Environmental Impact Statement – Supplementary Report

NOLANS PROJECT
ARAFURA RESOURCES LTD

OCTOBER 2017

Figure 3-4 Riparian vegetation impact area

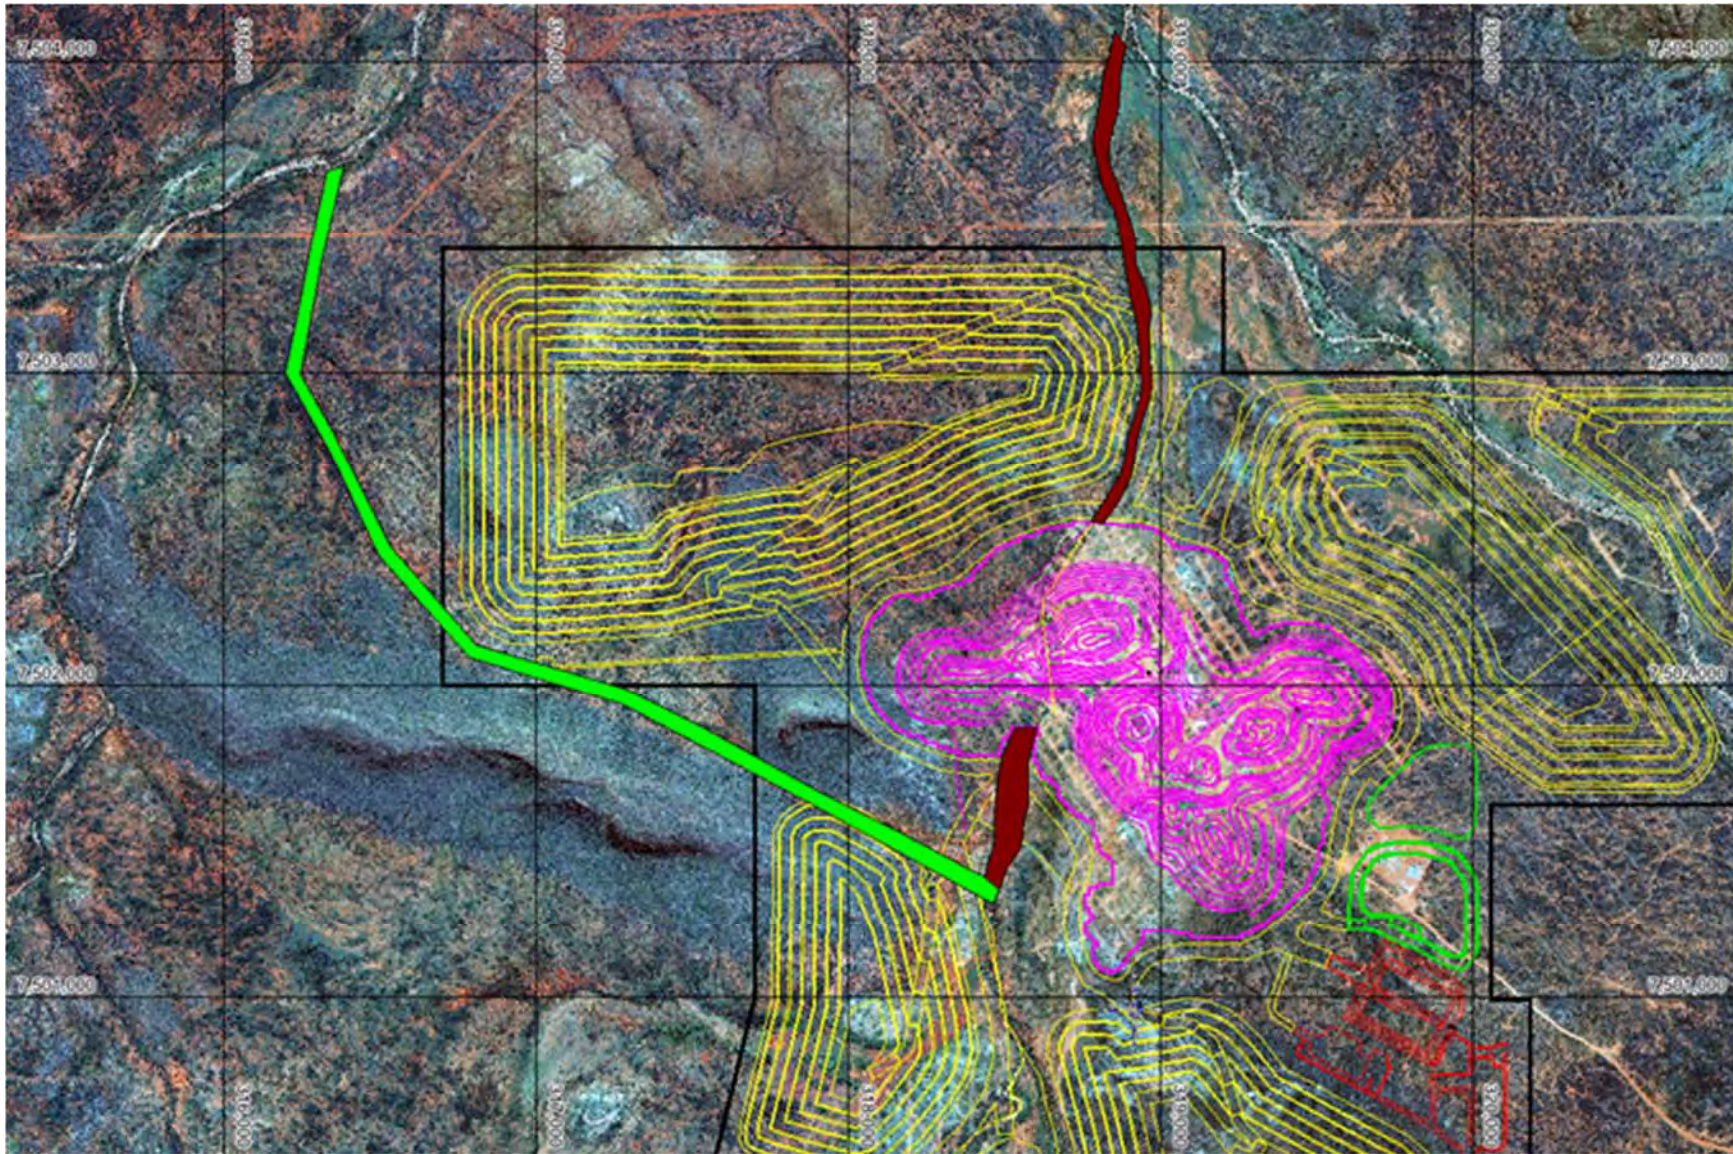
UID	Summary of submission	Response
	change in direction of the diverted creek described in the report, please discuss why this was selected.	demands of the project and to minimise the risk of contaminating creek flows, without significantly effecting the proposed mining operations. Additionally, the topography, drainage and hard rock suit a diversion in this location. The proposed diversion will include flood protection bunds to separate the clean water within the diversion from the dirty water generated by the adjacent mining areas. The final detailed design will be designed by a suitably qualified engineer to provide adequate erosion and scour protection.
235	Riparian vegetation impacts a) Clarify what the area (ha) of riparian vegetation is which will be irreversibly impacted by the Kerosene Creek Diversion.	The riparian vegetation corridor along Kerosene Camp Creek is variable in width. In some places it is constrained and limited to a narrow ribbon along each side of the creek, in other places it widens a little or is spread out as the creek itself opens into multiple flood out channels. Riparian vegetation has been mapped in the project footprint (Figure 3-3). The riparian vegetation immediately adjacent to the mine area, both upstream to the point of the diversion and downstream in Kerosene Camp Creek to the confluence of Nolans Creek is likely to be significantly impacted by the mining operations (i.e. riparian vegetation will die and not recolonise the area). This is depicted in Figure 3-4 as the brown area. A reasonable estimate for the down gradient extent of this impact is based on the point where Kerosene Camp Creek receives additional surface water flow from adjacent catchments. This point is the confluence with Nolans Creek. This length of Kerosene Camp Creek beyond the mining area is approximately 1 km long. The estimated total area of impact is 11 ha, therefore approximately 11 ha of riparian vegetation will be irreversibly impacted by the Kerosene Creek Diversion.

Figure 3-5 Baseline dust deposition seasonal variation (based on normalised monthly values)

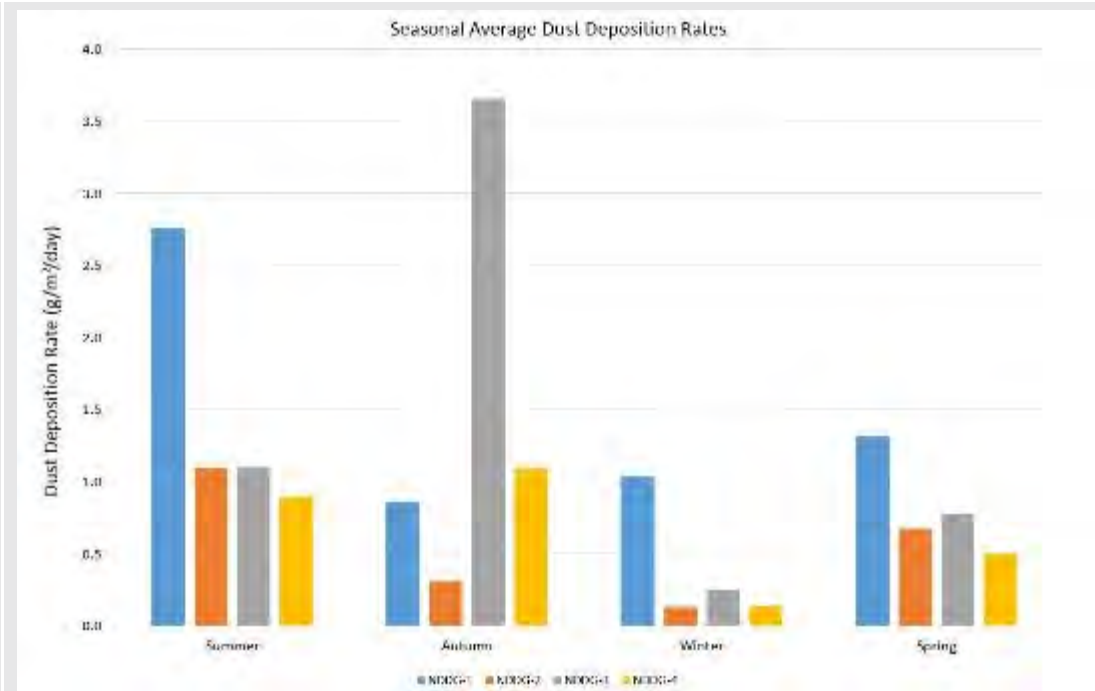
UID	Summary of submission	Response
3	Provide details on whether dust deposition gauge (DDG) equipment and monitoring was conducted according to Australian Standards AS/NZS 3580.10.1. The data presented in Figure 13-2 shows DDG's were not sampled monthly and baseline monthly seasonal variation year to year has not been provided. Fourteen monthly events were recorded off site above the assessment trigger which indicates dust impact will require management from mining activities. Provide details on other sources of dust generation other than the WRDS which may include the topsoil stockpiles, ROM, roads and traffic, processing plant and TSF/residues (if they do not have wet cover).	<u>Part A</u> Dust deposition gauge (DDG) equipment and monitoring was completed according to AS3580 specifically including AS3580.10.1, AS3580.10.2 and AS3580.14. DDGs were sampled over the two different periods of continuous monitoring: • October 2010 to August 2011 and • August 2012 to June 2015. AS3580.10.1 has a period of exposure for routine monitoring of typically 30 ± 2 days (Clause 7.3). However, due to practical considerations, the sampling period (t) in the number of days is a variable in equation 9.1 of the Australian Standard. Site issues associated with collecting monthly in a remote area were catered for by extending beyond 32 days. As long as the bottle does not overflow with rain, (soluble matter determination is invalid) and bottles are 'sun-shielded' to protect for algal growth, the deposition determination over a longer period than 32 days can be legitimately normalised to a monthly value. However, routine monitoring when the mine is operational is recommended on the first day of the month, so as to meet the typical exposure period of 30 ± 2 days. Figure 13-2 in the EIS outlines the baseline monthly variation (based on normalised monthly values) for a period of three years between August 2012 and June 2015 (plus 2010/2011). Baseline seasonal variation (based on normalised monthly values) for the period of monitoring is presented in Figure 3-5.

Figure 3-9 Reaphook Channel (left) through to The Margins (high point) and the south-eastern extreme of the Ti-Tree Basin (right) (West to East)

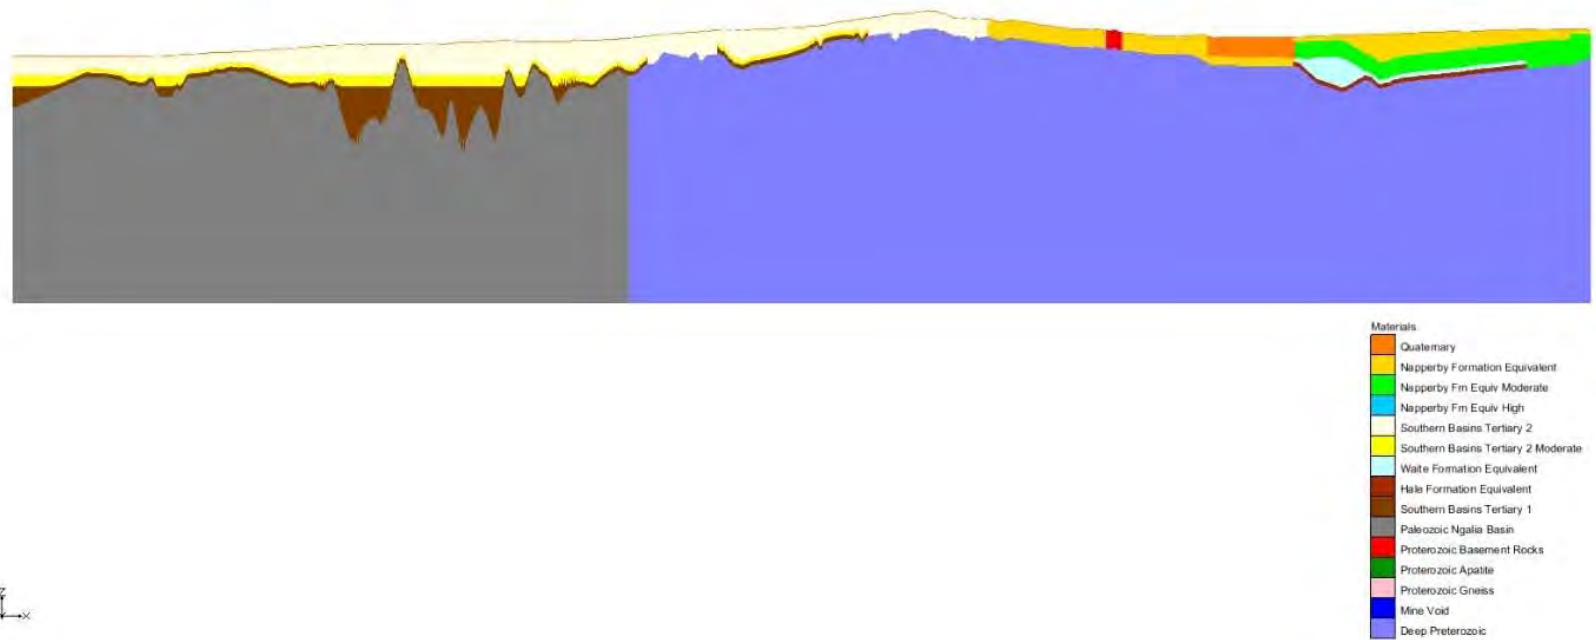
161	Provision of a cross-section through the hydrogeological model would assist in understanding its set up.	Due to the broad area and significant complexity in geometry, sections through the model vary significantly. Key sections that demonstrate the key model areas have been made and represented in the digital appendix (Appendix 8). An extract from the digital appendix is presented below (Figure 3-9 and Figure 3-10). The digital appendix contains a visualisation of the model geometry and conceptual hydrogeology (Appendix 8).

Figure 3-13 Radiation monitoring points (Appendix P of EIS)

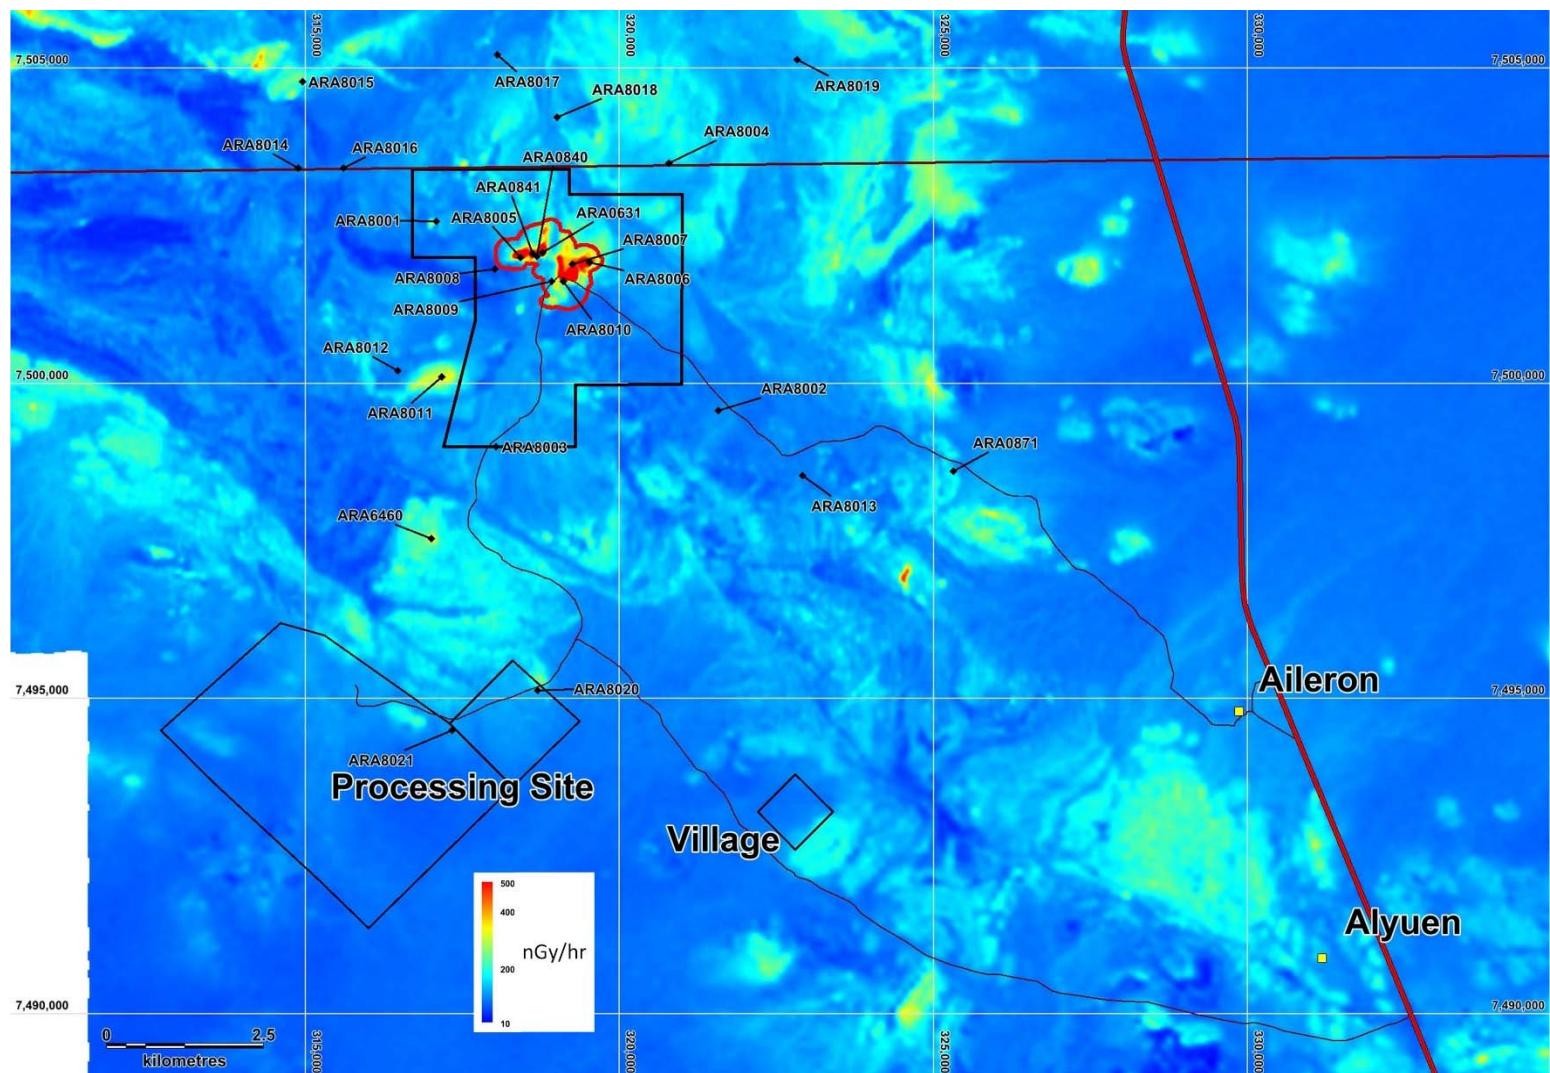
492	'A general area survey was conducted in a grid pattern across the mine site area and at sites remote from the project area. The remote sites are referred to as "background sites" and include two measurements in Kerosene Camp Creek and two measurements at the Aileron Roadhouse.' Kerosene camp Ck sites (incl. ARA08011) are mentioned as being used as 'background' sites. Sites ARA8014-016 and ARA8011 are shown in Aerial	The monitoring locations, detailed in Figure 3-8, show that the sites are widespread and representative of the area. Furthermore it should be noted that it would be remiss to omit a few higher spots as isolated higher spots up to 1000m² or more occur in the region. This was explained in the regional geology and background section of Hussey in Appendix P of the EIS. These isolated spots are not mineralisation. They are natural concentrations in rocks and soils. The figure shows the location of the environmental monitoring sites based on a calibrated high-resolution detailed low-level airborne radiometric image. This image shows the natural variations in radioactivity and the environmental dose rate across the project area. The image is a linear stretch of the data with all values of 500nGy/hr or more all shown as red. Hence

UID	Summary of submission	Response
	gamma surveys (Figure 12-2) to be localised gamma radiation hotspots (another deposit?). Their use may therefore skew calculation of local 'background' radiation conditions, particularly if they represent a large proportion of the data points used to calculate a 'background' value (Table 12-1). Provide justification for selected locations and groupings of monitoring points underlying calculations of radiation levels onsite.	this image emphasises the variation in the lower values. The cooler colours on this image have lower natural background radioactivity. The warmer colours have higher natural background radioactivity. The images clearly shows that the selected sites are representative of the area. Arafura completed several detailed grid-based surveys over the deposits area to determine the natural environmental radioactivity in the deposit area. These and the environmental monitoring sites were used to confirm the calibration of the airborne survey, see Hussey in Appendix P of EIS. All environmental monitoring sites were originally selected based on Arafura's knowledge of the region and geoscientific data. However, the actual spots were sited once ground-truthing was completed by Arafura's Senior Field Supervisor at each location. The selection was primarily based on the vegetation and soil cover at or near each site. Some places were up to 100m from the proposed target spot. The instructions provided to field staff was to find a point near this target spot that was easy to access and had sufficient soil and vegetation (grass/trees) for paired sampling. This was considered a very important factor in the site selection we believe the assessment of radioactive uptake is also an important factor to understand. Hence the actual monitoring spot was not biased in its selection based on measuring background radioactivity at each site. This measurement was taken after the fact. Environmental monitoring sites within the pit were based on Arafura's geological knowledge however the location of vegetation governed the actual site selection. These sites are considered typical of the deposit. They are not the areas of known highest radioactivity within the deposit footprint. The sites outside of the pit were selected as follows. • ARA8001-ARA8004 inclusive are long-term dust monitoring sites outside of the deposit footprint area. These are upwind, downwind and orthogonal to the prevailing wind direction. It made sense to add these to the list of environmental radiation monitoring sites to enable long term collection of data. • ARA8008 was selected as a low radioactivity area just outside of the pit. This site may be too close to the LOM pit but it will serve as a useful monitoring site for many years to come. The other sites were targeted by considering the location of the pit and infrastructure together with the prevailing wind direction and distance from the ML or pit.

UID	Summary of submission	Response
		• A group of sites were selected at about 1km from the ML. These are ARA8012, ARA8016, and ARA8018 to the W, NW and N. Another group of sites were selected at about 5km from the centre of the pit. These are ARA8014, ARA8015, ARA8017. These have variable but mostly low environmental radiation levels. Some of these are likely to form key additional downwind monitoring sites. • ARA8013 and ARA8019 were selected as distal background sites. ARA8013 is significantly upwind while ARA8019 is orthogonal and significant distance from Nolans. ARA0871 has been used as a standard background biogeochemical (vegetation) sampling site for almost 10 years. It made sense to include this site as well as the most distal upwind site. • ARA8011 was specifically targeted as example of an average outcrop of felsic granitic gneiss from this area. The radioactivity is slightly higher than its surrounds but it is similar to many other felsic gneiss outcrops in the region. Site ARA8012 would have similar radioactivity to ARA8011 if the soil was removed. This is also similar to some of the gneiss that hosts the deposit. • ARA6460 was specifically targeted by me based on geological reconnaissance mapping of radiometric exploration targets. This general location is another felsic granitic gneiss outcrop with naturally elevated radioactivity although it contains an elongate pod of biotite schist with near this spot. The monitoring site is located within an area of high natural background radioactivity and is similar to that observed at Nolans Bore. ARA6460 is not sited on the highest radioactivity. A larger area of higher background activity occurs about 7.5 km E of ARA6460. This site is also similar to Nolans Bore but it has not been targeted. Two sites were targeted within the processing site. The dose rate image clearly shows that the village site has similar of lower background radioactivity.
